RE: MP 08_0222 MOD 6 - Global Switch, City of Sydney Comments

Global Switch Stage 2

Lower Ground Facade Lighting

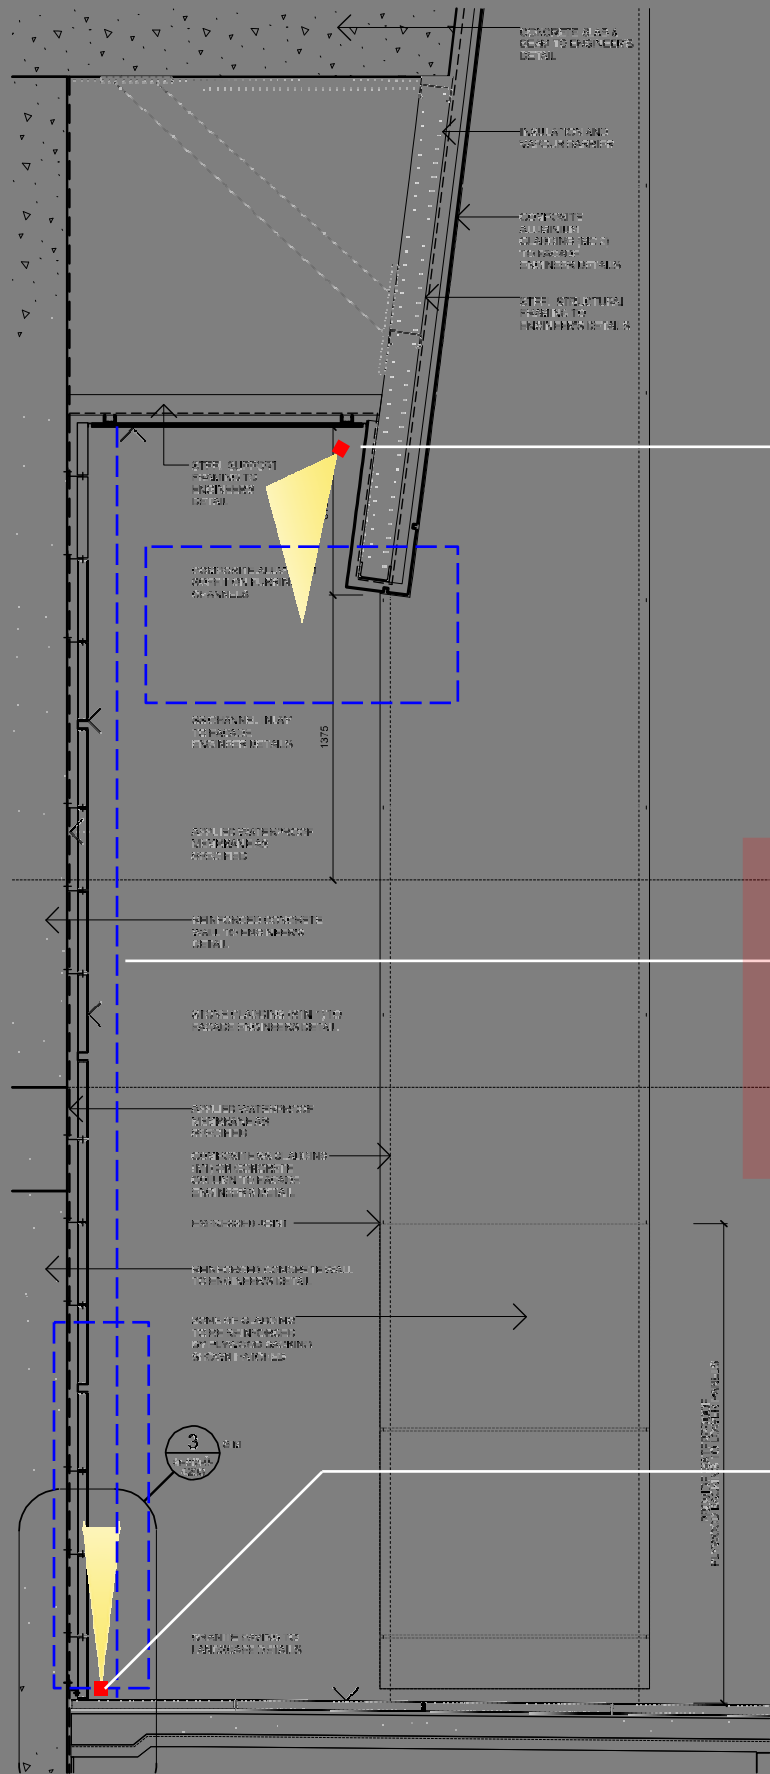
The extent of the proposed active wall treatment is as illustrated in the attached concept prepared by Global Switch's professional facade lighting consultant. This approach has been adopted to address the Department of Planning's initial concerns relating to potential light disturbance to residents directly opposite the site on Quarry Street. Global Switch also feels that maintaining elements of the sandstone façade treatment already approved as part of the original design creates better cohesion between the various stages of the building and in the wider the urban context in terms of both an architecture and aesthetics.

Perforated screen panelling allows for two illuminated planes. Illuminating these two planes with varying colour hue/saturation creates a dynamic visual effect and contrast.

Back lit wall lighting to silhouette facade screen panelling. Surface mounted linear profile with narrow optics grazing up the wall.

Front projection (flood lighting) via concealed luminaires at high level beneath awning canopy.
